ATR on Quality Control Check Report. (Bungalows)

Bungalow No	55	QC report stage	Plinth beam	Sl. No.	31690
Company	Gov LLP	Project	Gov	Phase	IX
Prepared by	V. Veerabrahman	Sign	V. Veerabrahman	Date	11-10-2018
Project Manager	K. Prakasham	Sign		Date	11-10-2018
Receipt by QC date		Sign		Other	
Receipt at HO date		Sign		Other	
Checked By MD on		MD Sign		For filling	<input type="checkbox"/> Yes <input type="checkbox"/> No

**Quality Control Check Report. Stage: Before Casting Plinth Beam (Villas)**

Description	Direction	Owners & Developers :	Date :	Promoted by
QUALITY CONTROL PLINTH BEAM CHECK PLAN TYPE-A1 (3BHK)	N	Silver Oak Realty	15.11.2017	Modi Properties & Investments Pvt. Ltd.
		Project Name & Phase :	Nagalaxmi	
		Silver Oak Villas	Approved By : Soham Modi	Phone:+91-40-6633555
			Scale :	N.T.S

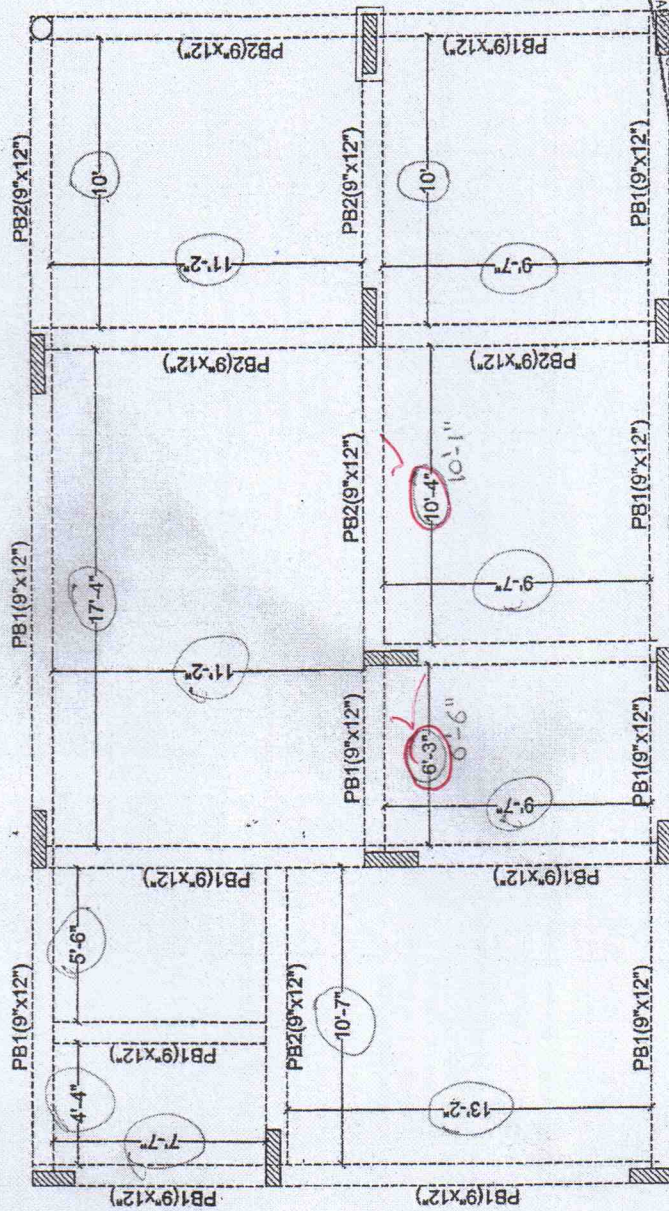
Remarks: For Two Plinth beam Measurement were Corrected
